VIEUX CHENES SUBDIVISION

Engineering Comments: **FINAL PLAT COMMENTS** (should be addressed prior to submitting the FINAL PLAT for review and/or signature by the City Engineer):

APPLICATION NUMBER 3 DATE May 19, 2022

DETAIL SITE PLAN

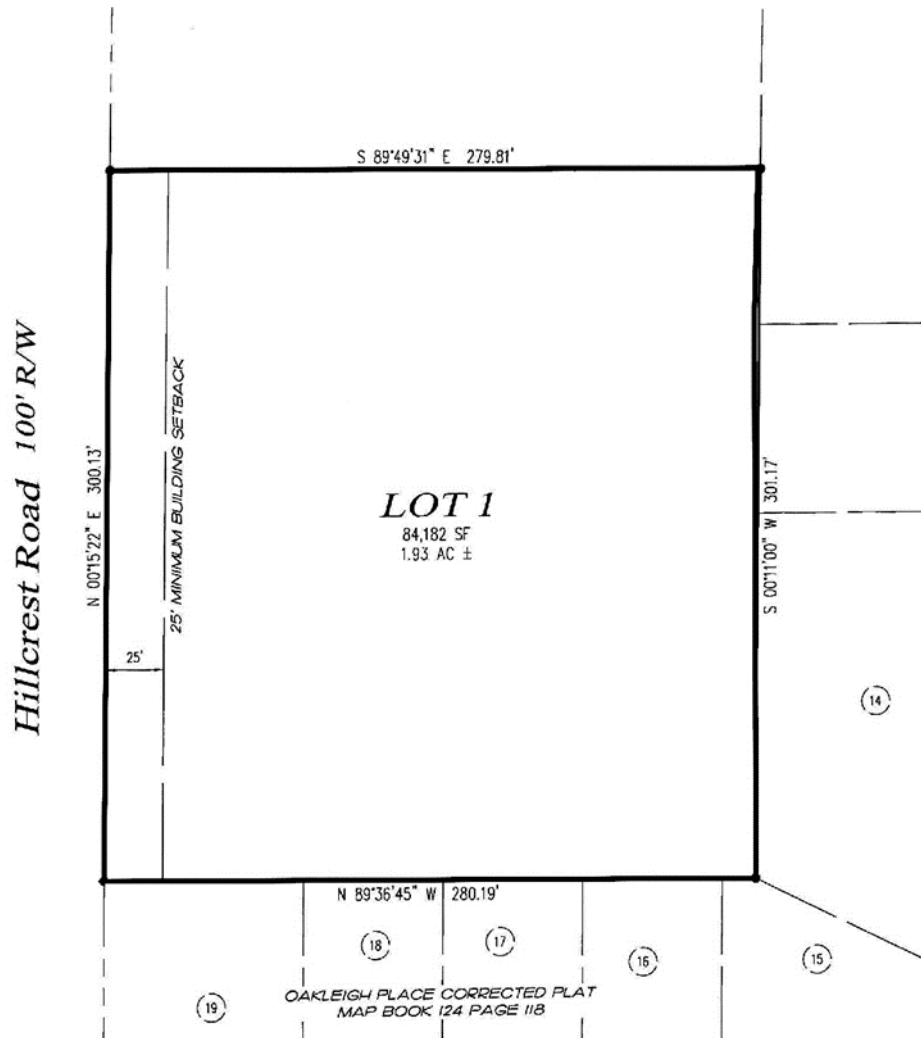
- A. Provide all of the required information on the SUBDIVISION PLAT (i.e. signature blocks, signatures, certification statements, written legal description, required notes, legend, scale, bearings and distances) that is required by the current Alabama State Board of Licensure for Professional Engineers and Land Surveyors.

- B. Label the monument set or found at each subdivision corner.
- C. Add a graphic scale.
- D. Add a signature block for the Owner, Notary Public, Planning Commission, Traffic Engineer, and City Engineer.

- E. Provide the Surveyor's Certificate.
- F. Add a note to the SUBDIVISION PLAT stating that as shown on the 1984 aerial photo (FLIGHT 19 - #80) LOT 1 will be allowed the following amount of historical credit of existing (1984) impervious area towards stormwater detention requirement per Mobile City Code, Chapter 17, Storm Water Management and Flood Control) as follows: LOT 1 – 3700 sqft.

- G. Add a note that a Land Disturbance permit will be required for any land disturbing activity in accordance with Mobile City Code, Chapter 17, Storm Water Management and Flood Control); the City of Mobile, Alabama Flood Plain Management Plan (1984); and, the Rules For Erosion and Sedimentation Control and Storm Water Runoff Control.

- H. Add a note that the approval of all applicable federal, state, and local agencies (including all storm water runoff, wetland and floodplain requirements) will be required prior to the issuance of a Land Disturbance permit.

- I. Add a note that sidewalk is required to be constructed, and/or repaired, along the frontage of each lot, or parcel, at time of new development or construction, unless a sidewalk waiver is approved.

- J. Add a note that all existing and proposed detention facilities, common areas, and wetlands shall be the responsibility of the Property Owner(s), and not the responsibility of the City of Mobile.

- K. Add a note that all easements shall remain in effect until vacated through the proper Vacation process.
- L. Email a pdf copy of the FINAL SUBDIVISION PLAT and LETTER OF DECISION to the Permitting Engineering Dept. for review at land.disturbance@cityofmobile.org prior to obtaining any signatures. No signatures are required on the drawing.

Traffic Engineering Comments: Driveway number, size, location, and design to be approved by Traffic Engineering and conform to AASHTO standards.

The site has frontage on Hillcrest Road, a major street included in the Major Street Plan, which has existing compliant 100-foot right-of-way; therefore, no dedication would be required. As on the preliminary plat, the right-of-way width of Hillcrest Road should be retained on the Final Plat, if approved.

The plat indicates a 25-foot minimum building setback line along Hillcrest Road, and this should be retained on the Final Plat, if approved. The proposed lot meets the minimum size requirements of the Subdivision Regulations. As on the preliminary plat, the lot size label in both square feet and acres should be retained on the Final Plat, or a table should be furnished on the Final Plat providing the same information, if approved.

As per the Traffic Engineering comments, the driveway number, size, location, and design are to be approved by Traffic Engineering and conform to AASHTO standards. If approved, a note should be required on the Final Plat stating these comments.

The plat meets the minimum requirements of the Subdivision Regulations and is recommended for Tentative Approval subject to the following conditions:

- 1) retention of the right-of-way width of Hillcrest Road on the Final Plat;
- 2) retention of the 25-foot minimum building setback line along Hillcrest Road on the Final Plat;

- 3) retention of the lot size label in both square feet and acres on the Final Plat, or the furnishing of a table on the Final Plat providing the same information;

- 5) placement of a note on the Final Plat stating the Traffic Engineering comments: (Driveway number, size, location, and design to be approved by Traffic Engineering and conform to AASHTO standards.);
